November 19, 2020

Subject: Final Draft Version 6.0 ENERGY STAR® Central Air Conditioner and Heat Pump (CAC/HP) Specification and the Final Draft ENERGY STAR Cold Climate Heat Pump Controls Verification Procedure (CVP).

Figure 1: EER distribution for split system ACs at 16 SEER.
 Source: CA IOU analysis of the DOE CCMS database.

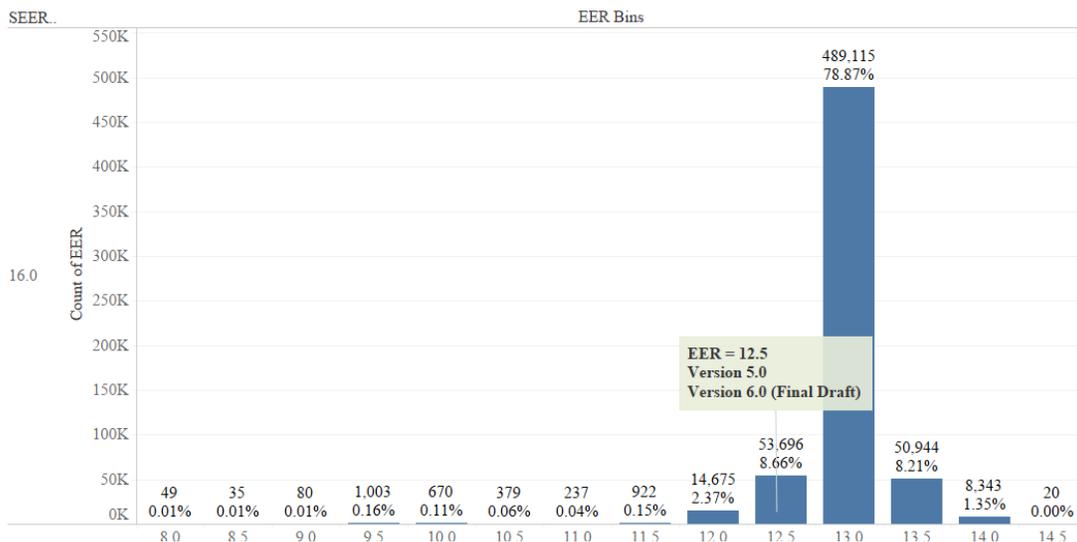
requirements. However, the CA IOUs reiterate our recommendation that EPA consider a higher efficiency ratings level for moderate and hot climates. While EPA increased the seasonal energy efficiency ratio (SEER) from 15.0 in the Version 5.0 Specification to 16.0 in the Drafts of the Version 6.0 Specification across all climates, the EER remained unchanged for the moderate and hot climates. In our previous comments,¹ we suggested that EPA consider increasing EER (and EER2) performance requirements for these climates pointing out that the performance level for CAC/HPs in the moderate and hot climates should be emphasized due to the greater cooling needs of those regions. However, while the SEER has been increased, we believe that attention on the impact of EER/EER2 was missing, which has a strong impact on peak energy usage. Based on a recent analysis of over five million products within DOE’s Compliance Certification Management Systems (CCMS) database,² we found that for split system air conditioners (ACs) and HPs, the current ENERGY STAR level of 12.5 EER was below the average EER for these types of units. The following figures below show the distribution of EER for split system ACs and split system HPs with a SEER of 16.0. In both cases, a majority of units are more efficient than the proposed Final Draft EER ratings. While we recognize that the CCMS database is not representative of sales distribution, we also note that EPA’s estimate of 2018 market penetration for air source HPs and CACs is 43 percent and 29 percent, respectively.³

Full load performance captured by EER has a large impact on the peak electrical usage. Similarly, peak electricity demands have had huge effects on energy procurement and energy pricing. As a result, we recommend EPA consider raising the EER/EER2 levels for CACs and split system HPs in the moderate and hot climates in the Version 6.0 Specification from the current levels of 12.5 EER/12.0 EER2 to 13.0 EER/12.5 EER2.
